Change Order Form

Project Title:	Ankeny Fire Station No. 3				
Contractor:	DDVI, Inc.				
Address:	1817 North 7th Street - Indianola, Iowa 50125				
Finance Budget Code:	get Code: 923.1923.4412 Finance Project Code:				
Vendor Project or Invoice #:		PO #	0		
Original Contract Date:	January 0, 190	00 Vendor #	3749

Change Order Number:	2	
Change Order Date:	October 16, 2017

Additional working days and compensation for the extra site work, exploration work, utility locating, additiona conduit runs, connections to transformers, and coordination needed to facilitate the relocation of the three phase MidAmerican electric cable to a location outside of the building footprint.

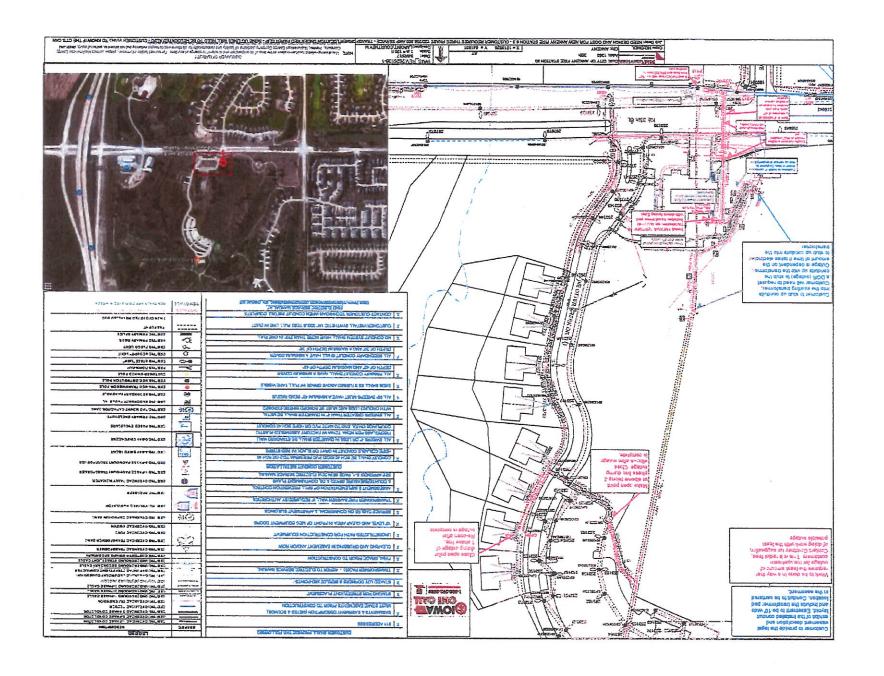
The cable will be relocated at the same time as we pull in wire in your customer own conduit and set the transformer **

Attached is a new print for work needing to be done at the Ankeny Fire station on NE 36th St. The customer will need to install the 2 new spans of conduit, as shown on the print. The conduit is to come from the new transformer location to the existing pump station transformer. It will then come from the existing pump station transformer to the transformer to the North. The reason for this relocation work is because it was found, out in the field, that the existing conduits are too shallow for the new grade.

In order for the electrician to install the required conduit, he will need to request 2 DORs (outages) to be able to stub the conduits up into the existing transformers. The length of outage depends on the amount of time it takes the electrician to complete his work. It would be preferred if the electrician makes sure the new conduits are toward the front, or in front of, the existing conduits/cables in the transformer. The electrician has the option to try to coordinate with our crews to stub up the conduits into the transformers at the same time an outage is scheduled by the crews for their work, to eliminate outages by the electrician. This would only be suggested if there is no room in the existing transformers to stub up the conduits.
